STAFF'S
REQUEST ANALYSIS
AND
RECOMMENDATION

04PR0263

IDI
(CARMAX)

REQUEST: Landscape plan approval for the proposed Carmax front sales lot as required by Condition 5 of zoning Case 84S079.

04PRO263-1

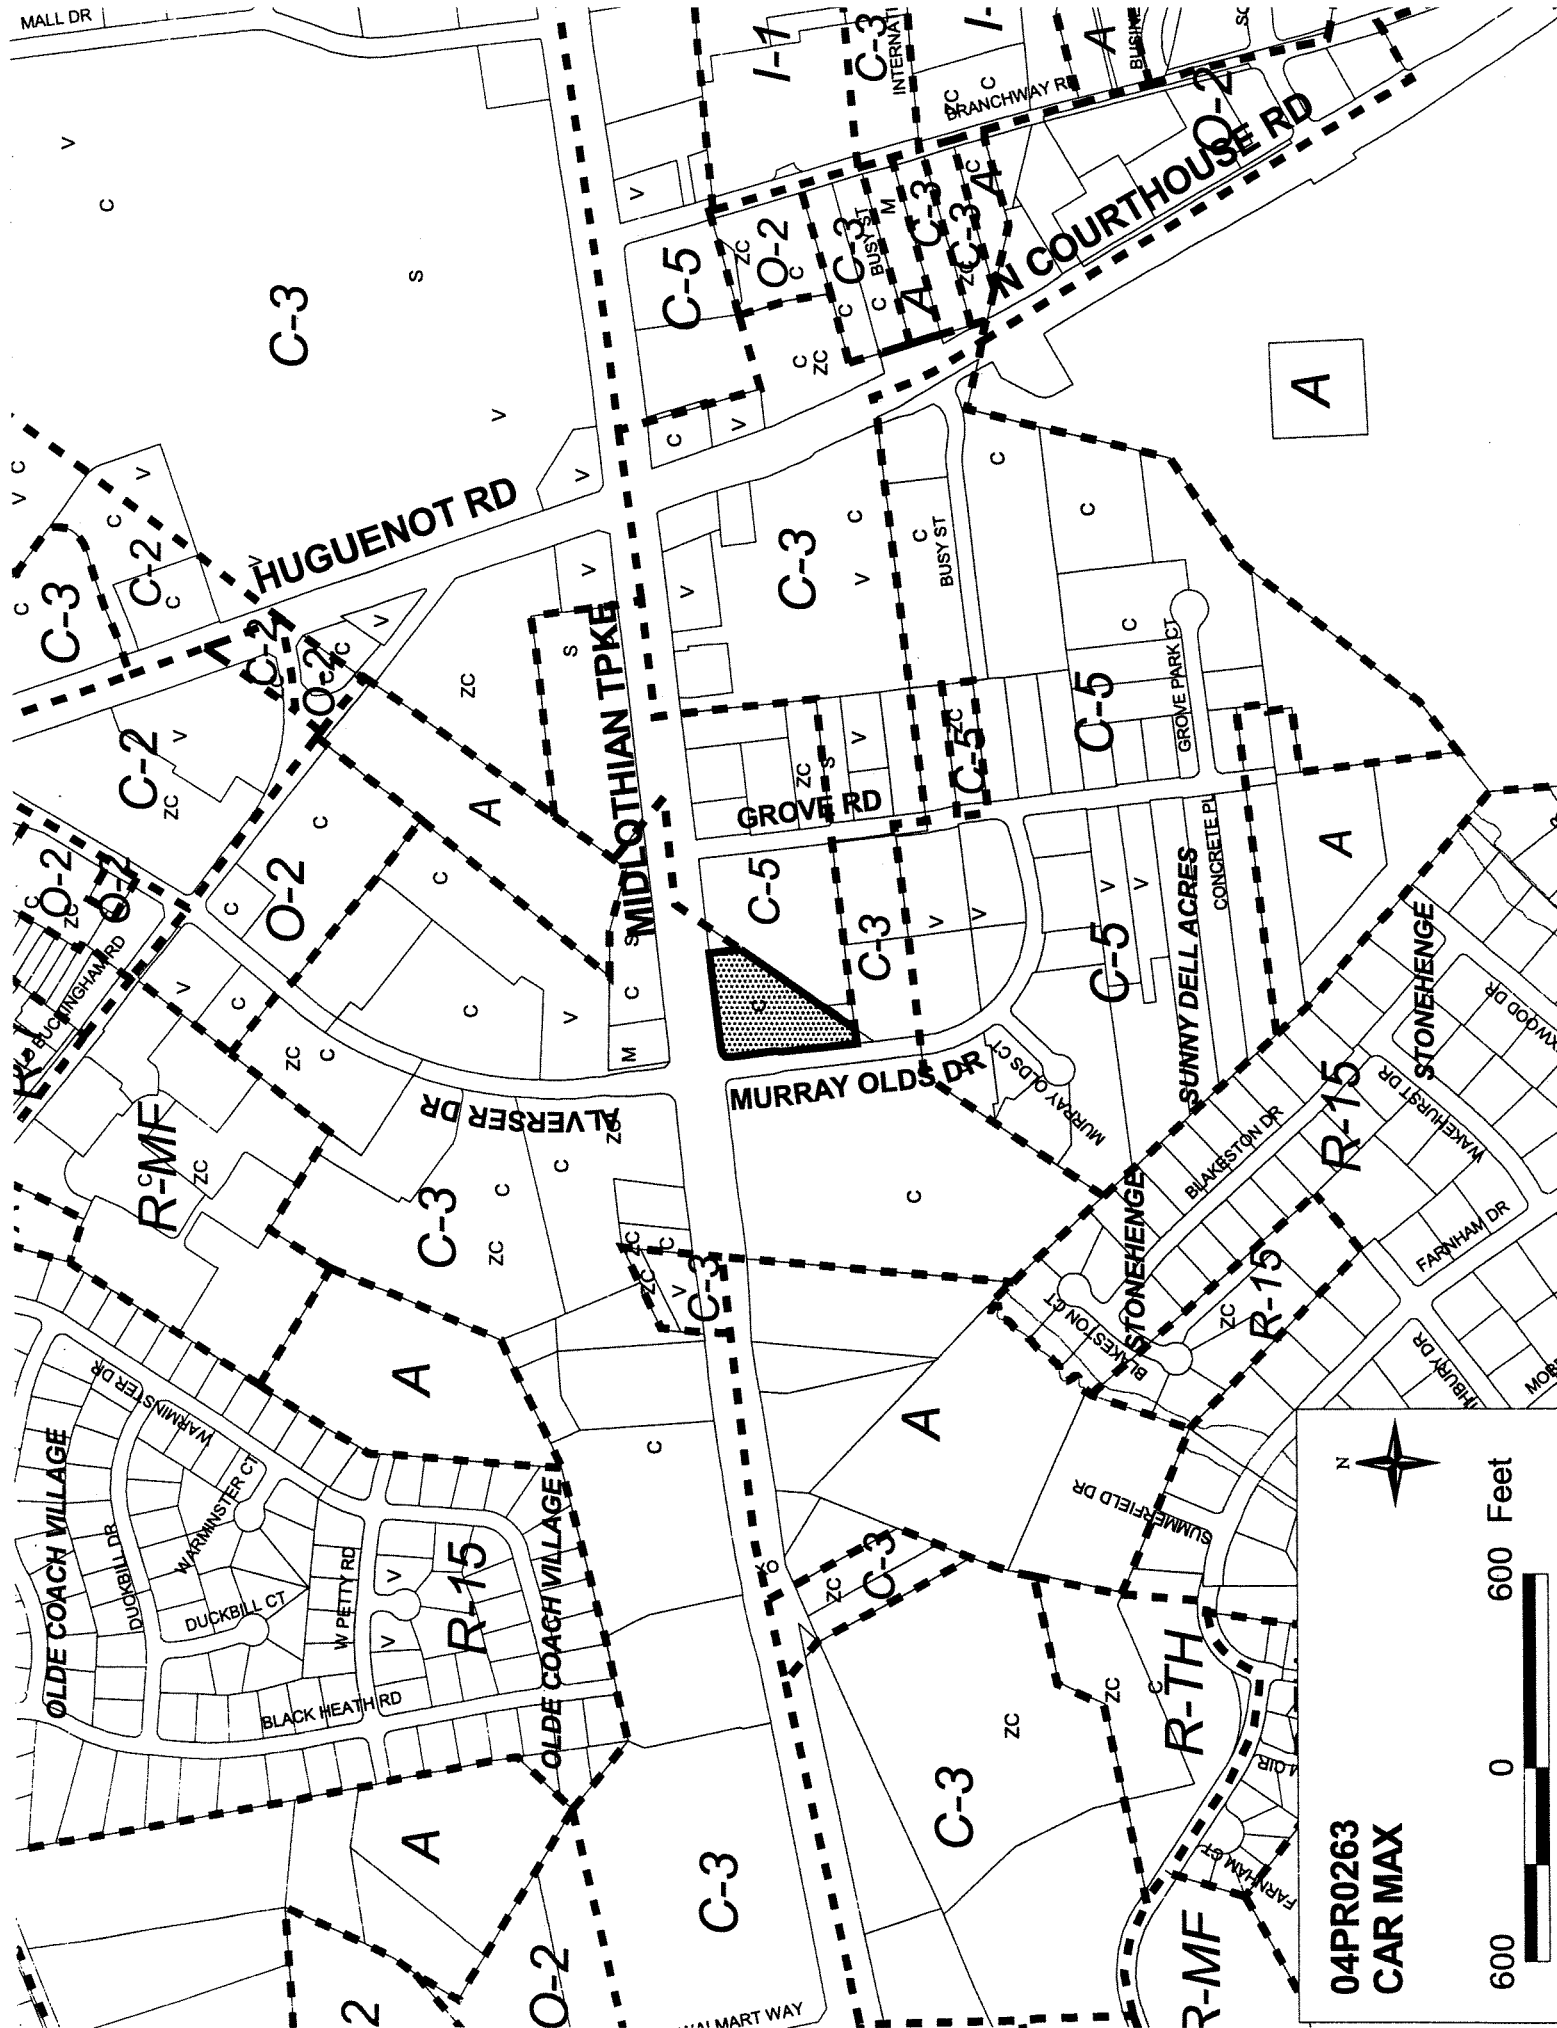
1. Remove the six (6) evergreens from Midlothian Turnpike setback.
2. Change the Athena Elm trees along Midlothian Turnpike to an approved small maturing shade tree.
3. Add one (1) Thornless Honeylocust tree to the area at the northeastern corner of the sales lot.
4. Two (2) additional small maturing shade trees shall be planted in the setback. These may be planted in line with the other small trees or in the right of way on either side of the existing western most maple tree (VDOT permit required.)

The current development plan for the site by Carmax involves overlaying the asphalt surface and leaving the existing curb in place. The original zoning case calls for ornamental plantings outside of the utility easements, however the plan approved in 1990 shows landscaping both within the parking area and in the easements (which have expanded since the original 1987 zoning case was approved). To meet current landscaping requirements and work around the utility easements, an additional tree will be placed in the sales lot adjacent to the right of way and a modification to the current requirement for landscaping will be installed. Landscape “J” is required along Midlothian Turnpike. Because the entire setback is a utility easement, to meet this requirement small trees will be planted in lieu of large trees and the required double row of evergreen shrubs will be planted. This is similar to the existing conditions and is acceptable to the Utility Department. Two (2) additional trees will be planted to make up the difference in size between large and small trees. They may be planted in line with the other small trees or planted in the right of way between the existing Armstrong Maples. If planted in the right of way a permit from VDOT is required.
